ADDENDUM NO. 03

Northland Corridor Redevelopment Project Phase 4
631 Northland Ave.
Buffalo, NY 14211

Project No. 432607

Project Northland Corridor Redevelopment Phase 4 (BUDC) Addendum No. 3
631 Northland Avenue, Buffalo, NY Contract -
Wendel Project No. 432607 Date 10/22/25

HM-100

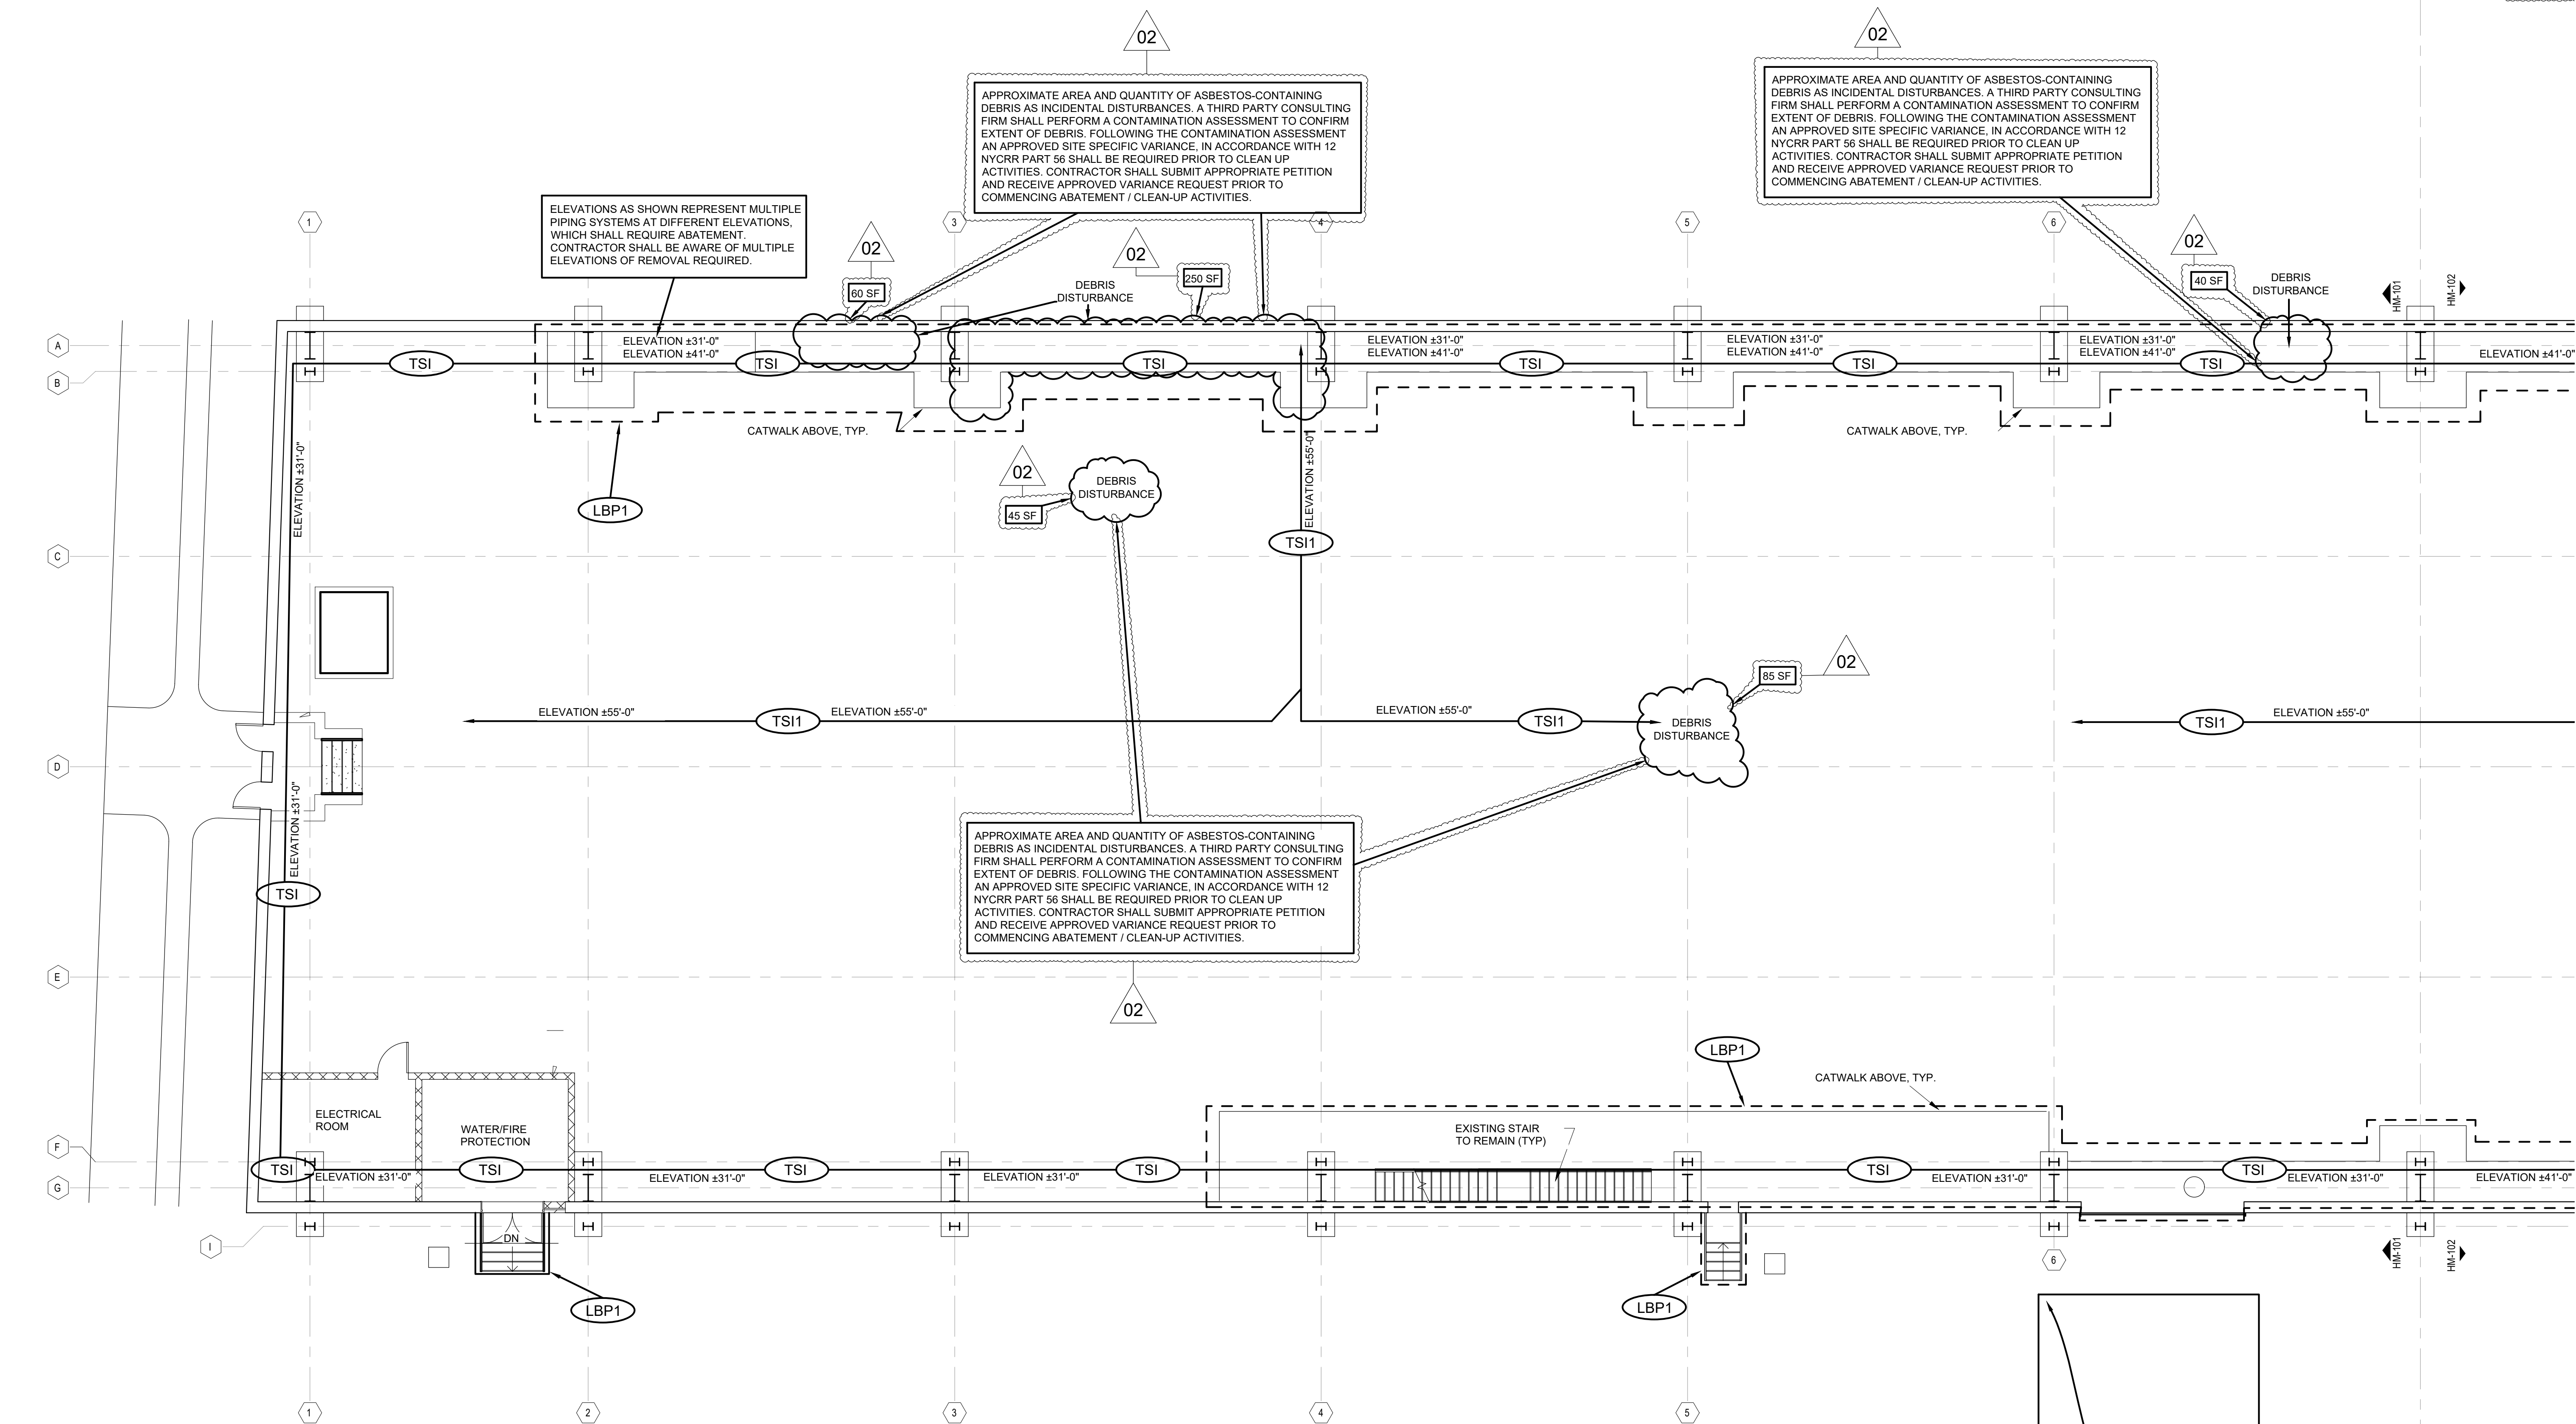
CLARIFICATION: Hazardous materials incidental disturbance areas and linear feet have been clarified on the revised referenced drawings issued as part of this addendum.

QUESTION: The HM drawing quantities show door caulk, electrical wiring, window caulk, window glazing, and mudded joint fittings in square footage. What was the conversion rate that was used to convert the quantities from linear footage to square footage as these items are usually shown as linear footage. For caulking it is normally 48 linear feet is equal to 1 square foot. For mudded fitting it is usually one fitting is equal to one linear foot what rate was used to convert it to square footage ?

ANSWER: In accordance with EPA Guidance RE&LS is limited to quantifying materials in linear feet to thermal systems insulation (piping, elbows, fittings) which do not exceed 12" diameter. As such, we have amended the quantities to show piping (MJP) as Linear Feet. The conversion rate used for MJP was equal to one fitting / elbow = one LF. For caulks / glazing associated with the windows, due to the number of layers present we accounted for one SF of material per window unit. For doors, due to multiple layers, we accounted for one SF per door. For electrical wiring insulation, we measured the assumed distance and took the width of the insulation to determine the quantity provided. Please refer to revised HM100 – 102 in this addendum.

C102

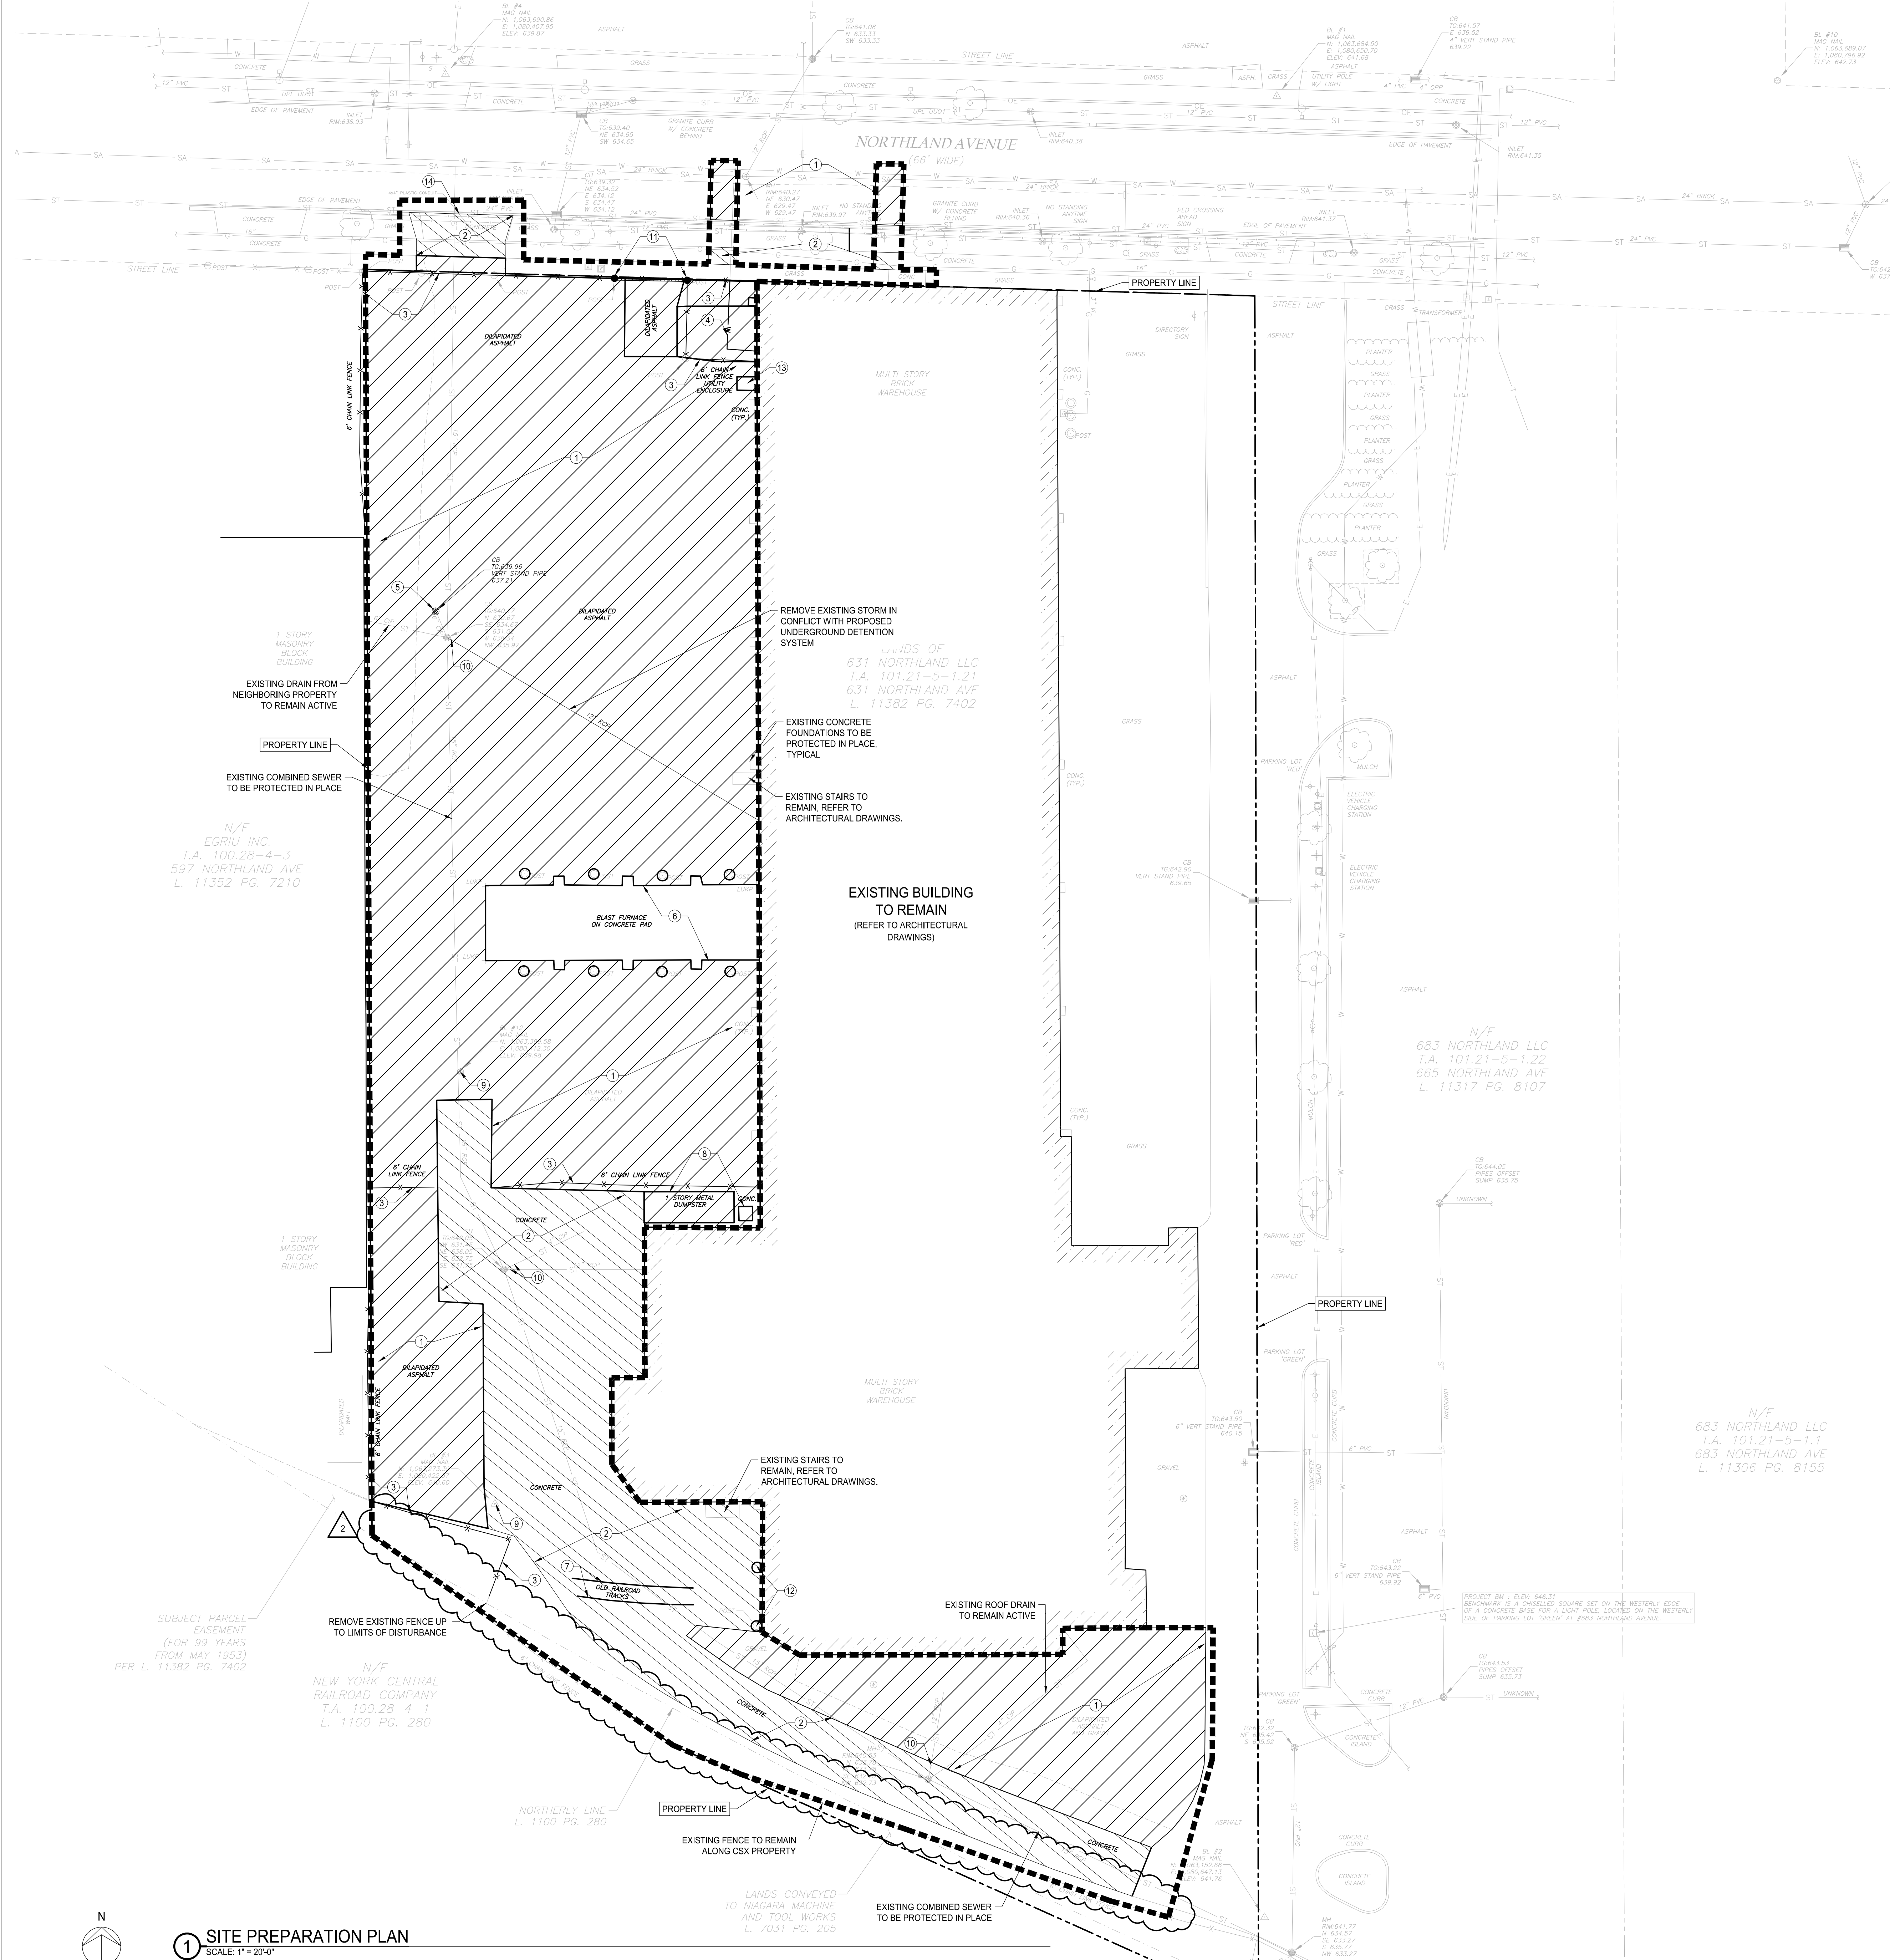
CLARIFICATION: Revisions in the above referenced sheets accommodate environmental requirements and provide clarification to utilities, drainage, and grading.

ADD: Revised civil drawings C102, C103, C201, C301, C302, C503, C504 issued as part of this addendum.
